**Traffic and Transport Expert Evidence  
North East Link Project**

Harwood Andrews on behalf of Manningham  
City Council.  
Our reference 16192REP001F01 North East  
Link Traffic Evidence Statement

Review of the Environment Effects Statement for the North East Link Project.

**Figure 5-3: Manningham Rd / NEL Interchange – Reference Design**

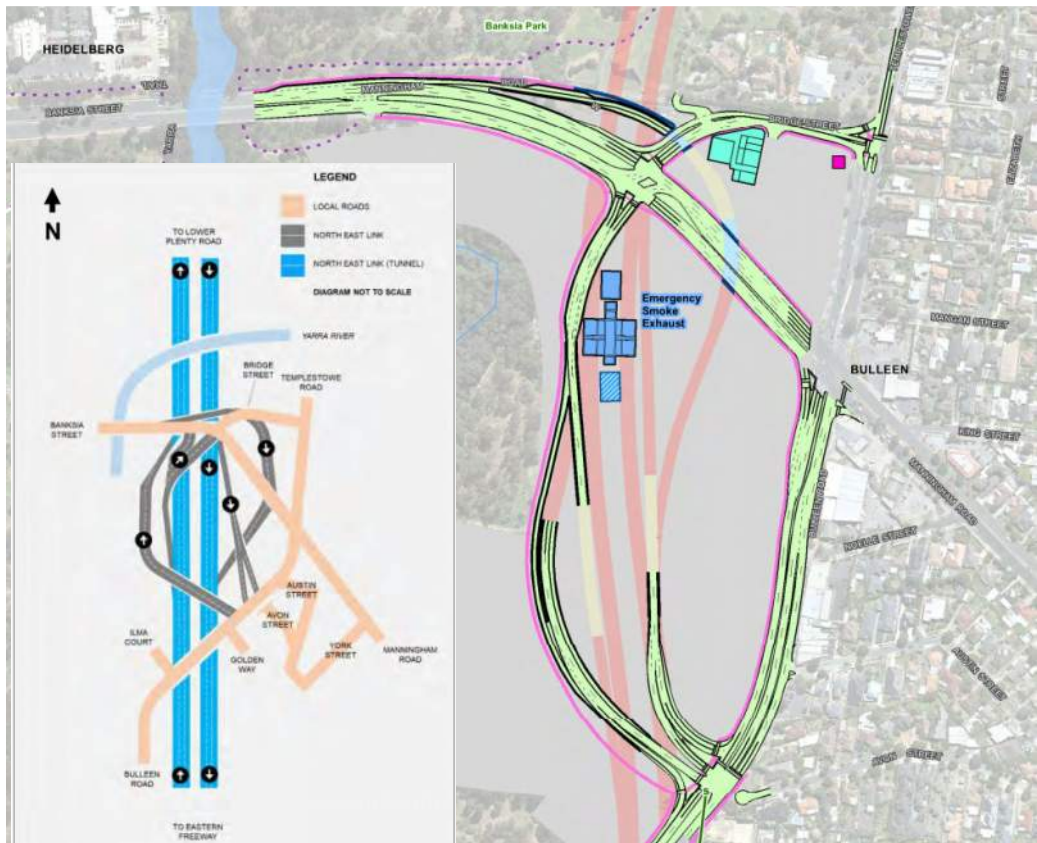
- 5.4.2 As shown on the preceding figure, access to and from the NEL is relatively complex and split between Manningham Road and Bulleen Road.
- 5.4.3 Pedestrian crossings have not been shown across Manningham Road at the new traffic signal.
- 5.4.4 Access to and from the NEL at the Manningham Road interchange is described as follows and demonstrated in the following figures.

**Figure 5-7: Manningham Road / NEL Interchange AM Peak 2036 Traffic Volumes**

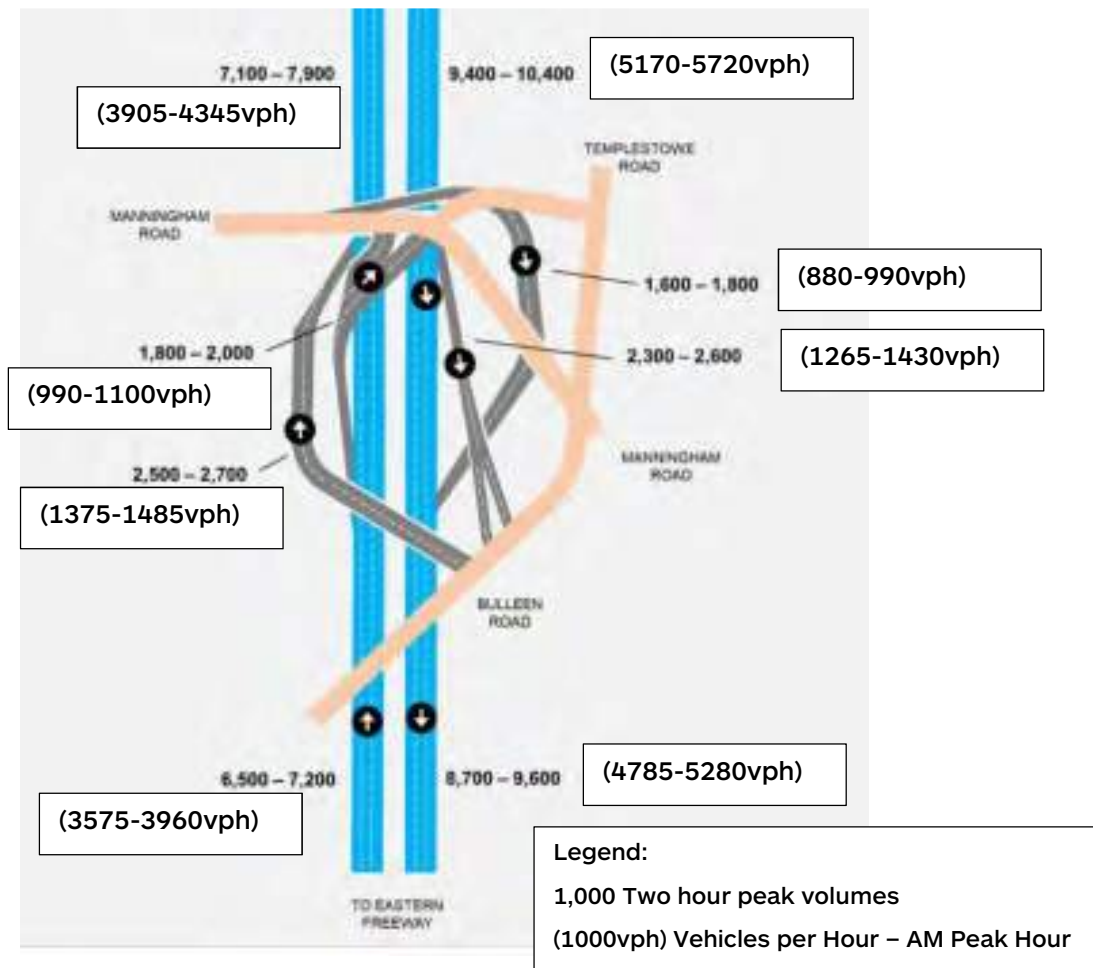
- 5.5.2 As shown in the preceding figure, approximately 880-990 vph are expected to enter NEL to head south from Manningham Road.
- 5.5.3 As discussed earlier, the proposed Reference Design only allows access to this entry from vehicles travelling eastbound on Manningham Road west of the Yarra River.
- 5.5.4 In my opinion it would be reasonable to expect motorists east of the Yarra River may also want to use the Manningham Road interchange to travel south on the NEL, which would provide convenient access to the Eastern Freeway (either east or west). The NEL is expected to provide a faster alternative to using Bulleen Road and avoids a number of new and existing traffic signals along Bulleen Road.
- 5.5.5 The traffic modelling does not provide sufficient detail to determine the likely demand of vehicles wishing to use the Manningham Road interchange to travel south. Therefore

**Figure 5-9: Manningham Rd / NEL Interchange – Alternate Design**

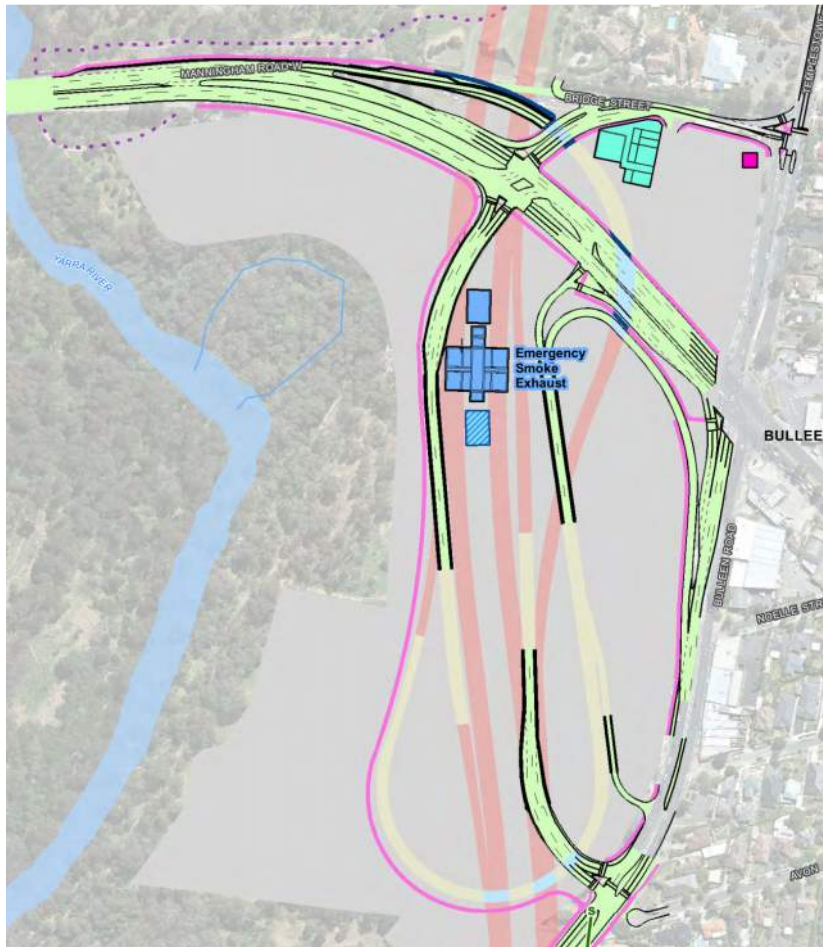
- 5.7.3 The proposed on-ramp is located approximately 50 metres east of the off ramps on Manningham Road, as shown in the preceding figure.
- 5.7.4 The separation between the off ramp and the on ramp on Manningham Road results in a short right turn lane on the western approach to the northbound on ramp, that appears to be unsignalised and as such will rely on gaps in the three westbound traffic lanes on Manningham Road, or courtesy gaps when the traffic comes to a stop at the adjacent traffic signals.

**Figure 5-13: Possible Manningham Road Interchange Concept**

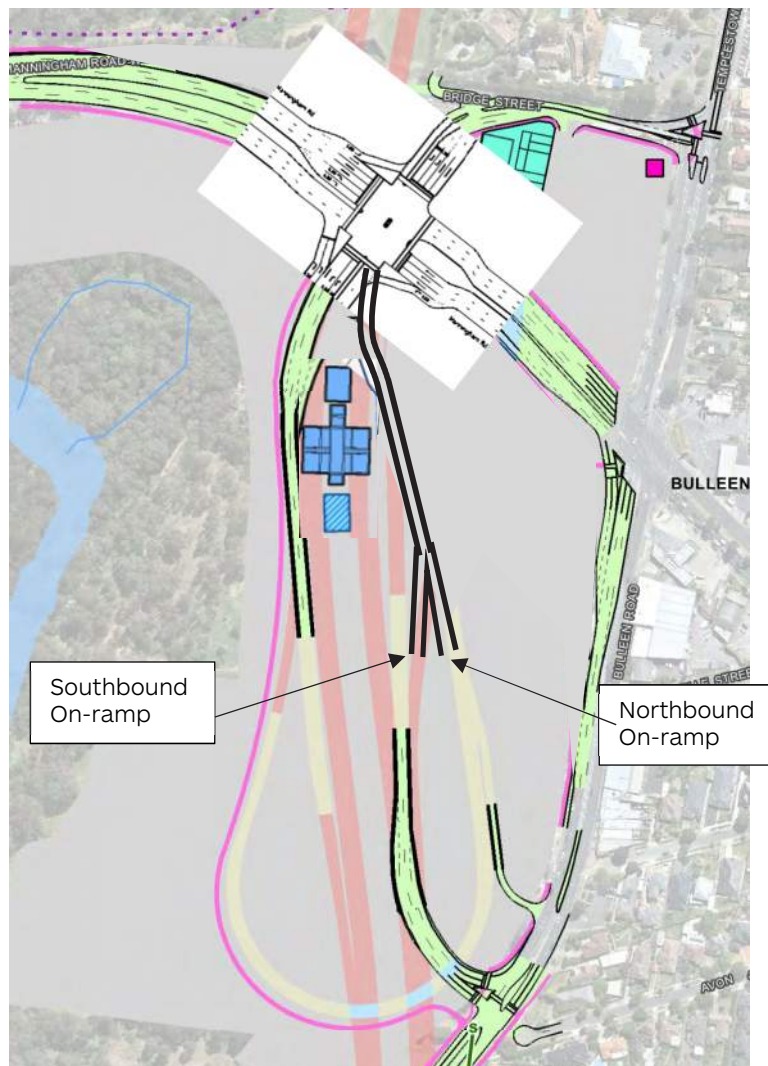
- 5.10.1 In my opinion, neither the Reference or the Alternate Design provide a satisfactory access arrangement from the Arterial Road network to what will be one of Melbourne's core circulation routes around the city.
- 5.10.2 If the northbound and southbound entry points to the NEL were combined and incorporated into the proposed traffic signal on Manningham Road, this would resolve all of the issues outlined above as follows:
- The right turn from Manningham Road would not only be controlled by the traffic signals but would also be able to have a much longer turn lane allowing

5.10.3 On that basis I have modified the EES Alternate Design and prepared a very basic concept layout that would address my concerns. The proposed concept is indicative only and prepared for the purpose of discussion only. I acknowledge that there are numerous options available, especially given the size of the land acquisition proposed adjacent to the Manningham Road interchange.

- 5.10.5 As shown in the preceding sketch, the egress for southbound traffic would still need to be retained at Bulleen Road, along with the circular underground loops to provide access for northbound vehicles entering the NEL.

**Figure 6-2: Surplus Developable Land in the Bulleen Industrial Precinct Post NEL**

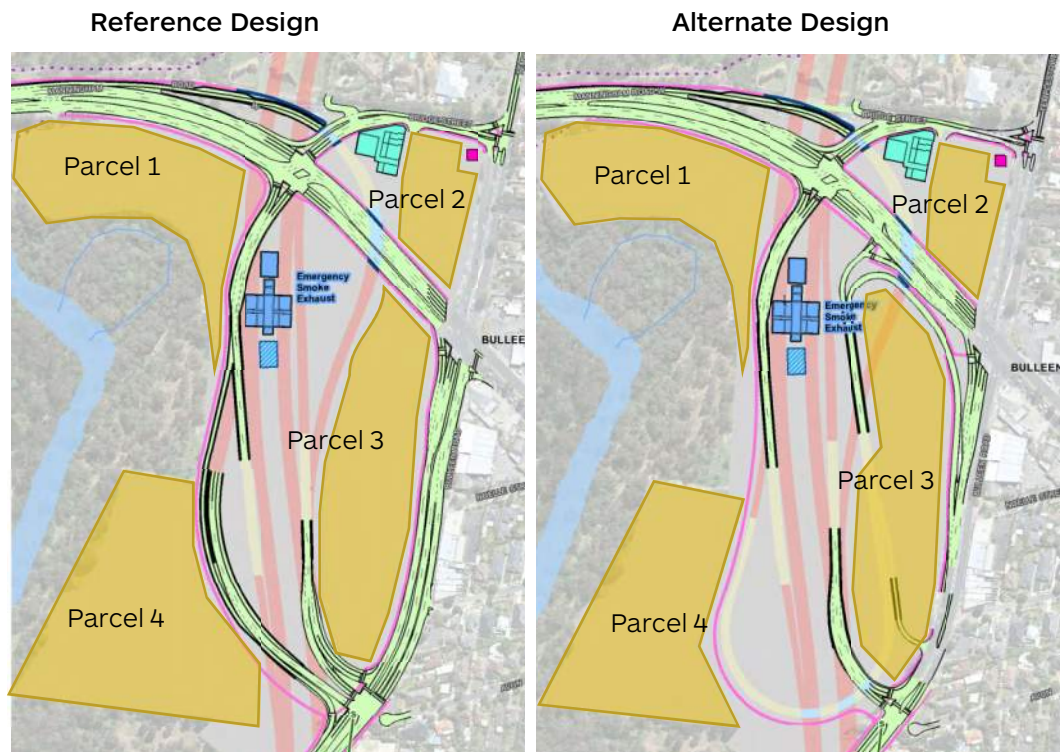
- 6.3.1 The Reference Design does not show access locations to the acquired land surrounding the Manningham Road interchange.
- 6.3.2 The Alternate Design shows some indicative access locations to the future surplus land within the Bulleen Industrial Precinct.
- 6.3.3 In order to visualise the extent of developable land that may be available post NEL construction, I have assumed that the land above the proposed tunnels is not developable along with entry and exit ramps. The 4 land parcels remaining are shown for both the Reference Design and Alternate Design in the following figures:

- 6.3.4 It is my expectation that the land shown in yellow above, will be able to be redeveloped post the NEL construction, subject to appropriate vehicular access.
- 6.3.5 As shown in the preceding comparison the useable land at the northern end of the Industrial Precinct will be very similar. The developable area adjacent to Bulleen Road and the portion in the south west corner are larger on the Reference Design compared to the Alternate Design.
- 6.3.6 The areas shown between ramps that are either at grade or open cut are considered unlikely to be developed due to the issue of crossing a freeway on / off ramp.
- 6.3.7 The success of redeveloping the redundant land and the density that can be achieved will be somewhat determined by the limitations of the vehicular access that can be achieved.

**Figure 6-3: Access Opportunities and Constraints to the Surplus Land in the Bulleen Industrial Precinct Post NEL**

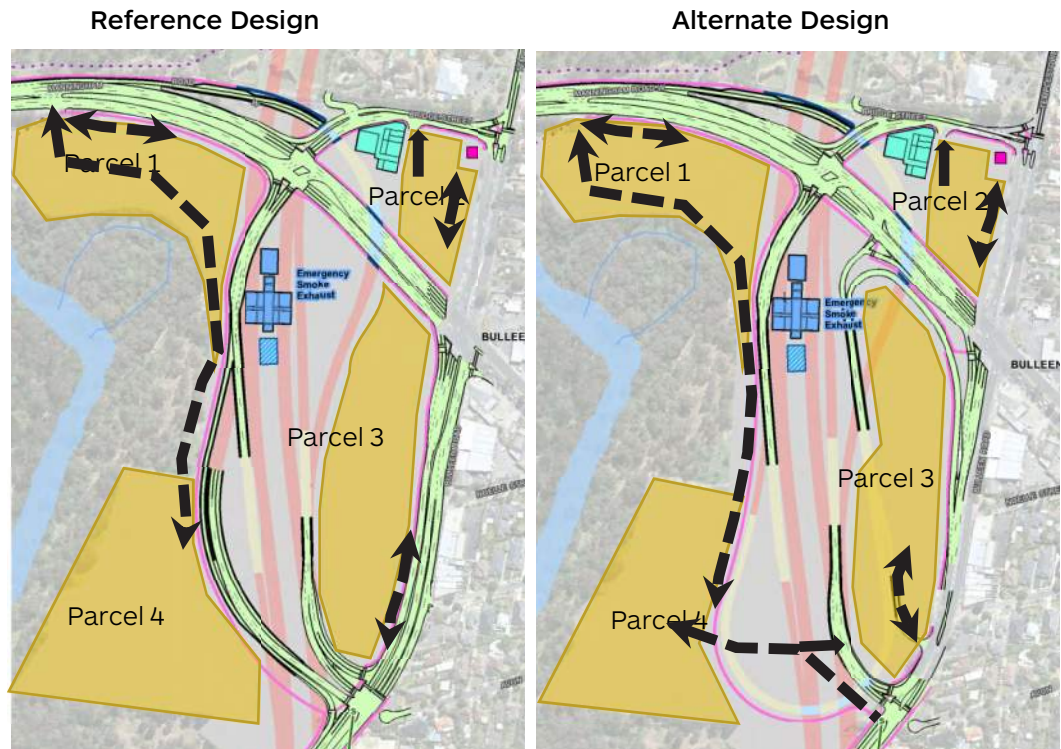
- 6.4.10 Under the Reference Design the north south link to Manningham Road is likely to be the only viable access solution. Any other alternative would require further acquisition of land to the south to provide a new connection to Bulleen Road.

- 6.4.11 The Alternate Design has more options to access Parcel 4 as the proposed traffic signal on Bulleen Road is serving southbound movements egressing the NEL at this location. Therefore, the other half of the intersection could be used to provide access to Parcel 4, as indicatively shown on the right hand side of Figure 6-3, with egressing vehicles using the NEL egress.

**Figure 8-2: NEL Reference Design Showing Access to Bulleen Park**

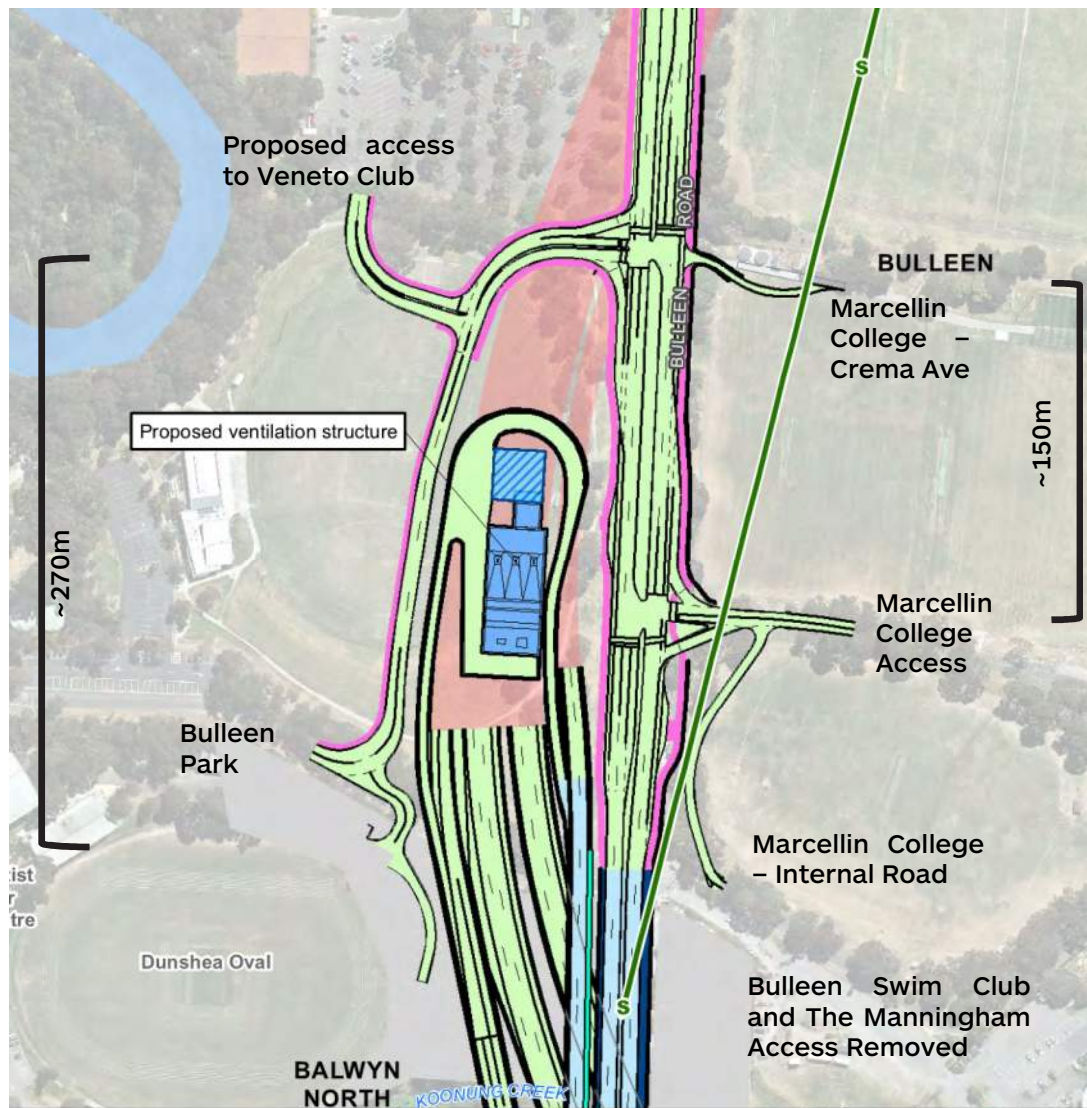
8.3.9 As shown in the preceding figure, the NEL will occupy approximately half of the existing oval.

- 8.4.1 As shown in the preceding figure, it is proposed to locate two new traffic signals on Bulleen Road. The signals will be approximately 150m apart. In my experience this is far closer than the typical minimum desirable spacing of 400m. The close proximity of the signals may result in drivers, driving through red lights, as they are focused on the further signal rather than the immediate set of lights, known as the see-through effect.

- 8.4.4 The traffic signal design also shows slip lanes both into and out of the minor intersection legs. Slip lanes can increase the efficiency of the intersection but are usually avoided in areas of high pedestrian activity.
- 8.4.5 Given the surrounding land uses of education and recreation, I believe the traffic signals in the Reference Design should be altered to show standard left turn lanes on all approaches where required.
- 8.4.6 A standard left turn lane reduces the speed vehicles enter the minor road and reduces the crossing distance for pedestrians.

- 8.4.9 The proposed intersection is approximately 270 metres further north than the existing access location.
- 8.4.10 The elevation of Bulleen Road and the construction of the NEL will effectively remove any pedestrian access to the east from south of the Eastern Freeway to the proposed traffic signal, a distance of approximately 850 metres.

**Figure 9-4: Proposed Eastern Freeway Cross Sections**

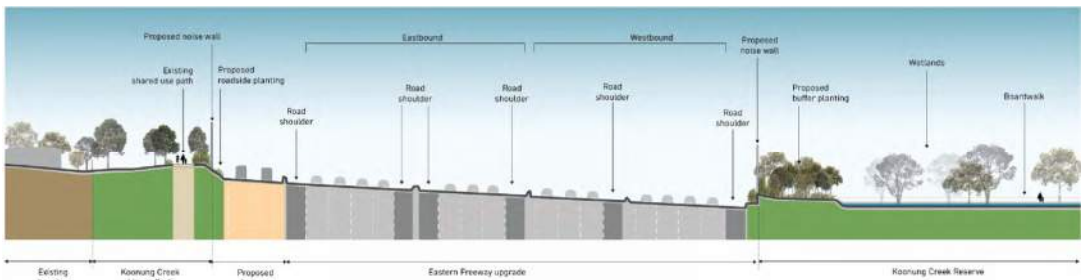
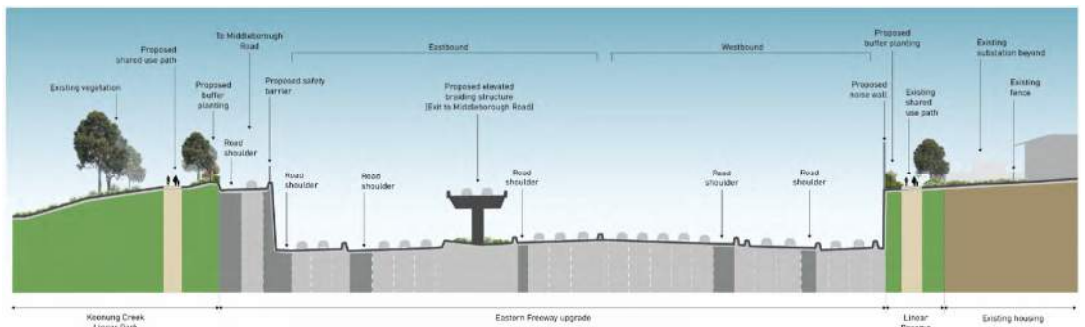
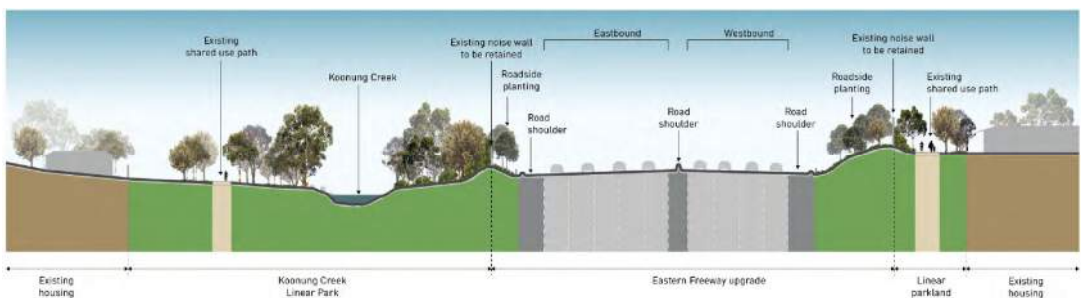
9.3.3 The first cross section includes Expressway lanes in both directions. The second cross section only includes Expressway lanes in the eastbound direction. No Expressway lanes are proposed in the third cross section.

9.3.4 As the Expressway lanes are proposed to be physically separated by barriers from the adjacent through lanes, additional width is required for shoulders abutting the barriers.

**Figure 10-2: Doncaster Road Park and Ride Bus Station**

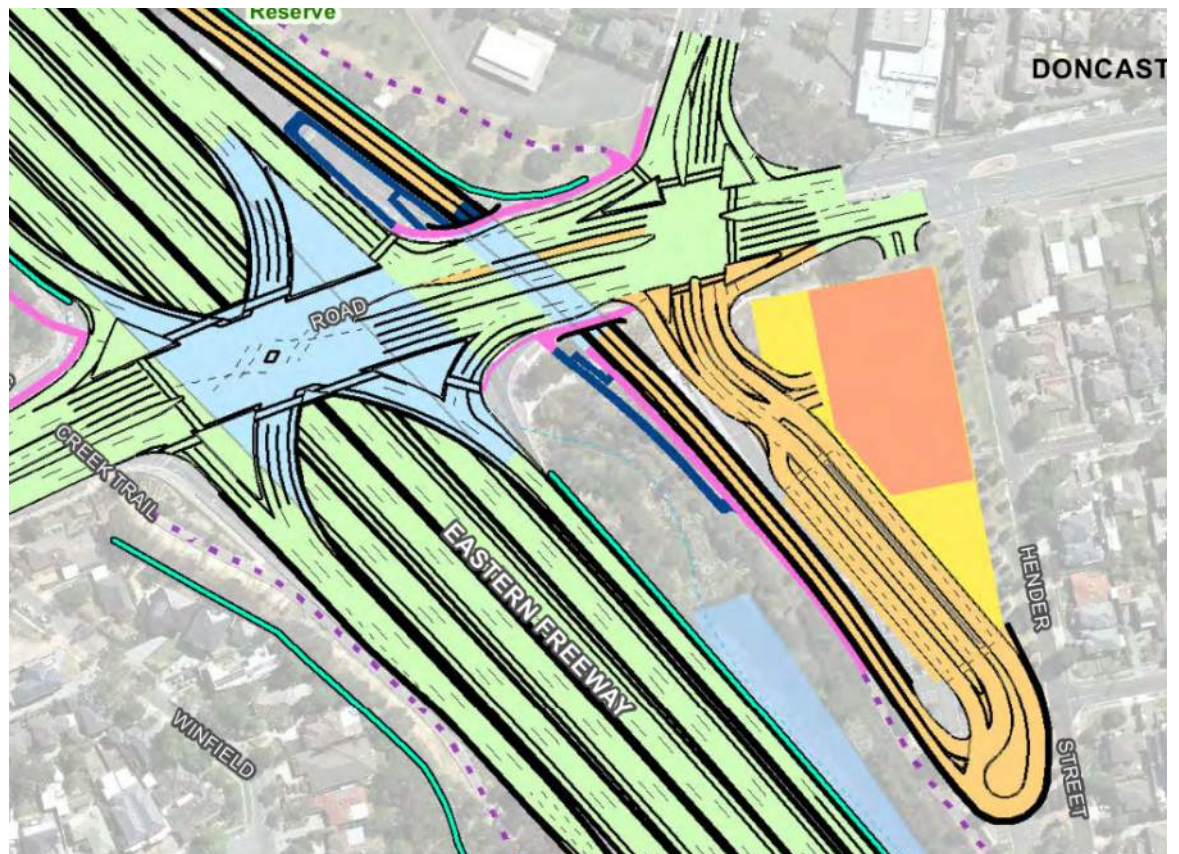
- 10.1.3 Although the traffic signal on Doncaster Road into the busway is colored orange, indicating that it serves buses only, I was advised by NELP that it will service both buses and commuter vehicles.
- 10.1.4 A new vehicle access is shown on Doncaster Road into the Park and Ride facility as a left in / left out access adjacent to Hender Street, as shown on the preceding figure.

- 10.1.7 As shown in the preceding figures, the proposed entry to the Park and Ride is extremely close to Hender Street and located within the left turn deceleration lane.
- 10.1.8 The Park and Ride will continue to provide approximately 400 parking spaces, with vehicle movements predominately inbound in the AM peak and outbound in the PM peak.
- 10.1.9 The introduction of a new access in this location is considered undesirable due to the potential for confusion between vehicles entering Hender St and vehicles turning left onto the Eastern Freeway.

- 10.1.10 I believe continuing to use the combined access at the existing traffic signal would provide the best access opportunities for both commuters and buses. Given the constraints of the site and the anticipated traffic volumes on Doncaster Road, I do not support the proposed left in / left out location on Doncaster Road.
- 10.1.11 This recommendation is made on the assumption that a shared access arrangement with Hender Street or closure of Hender Street would be undesirable to existing residents and Manningham Council.
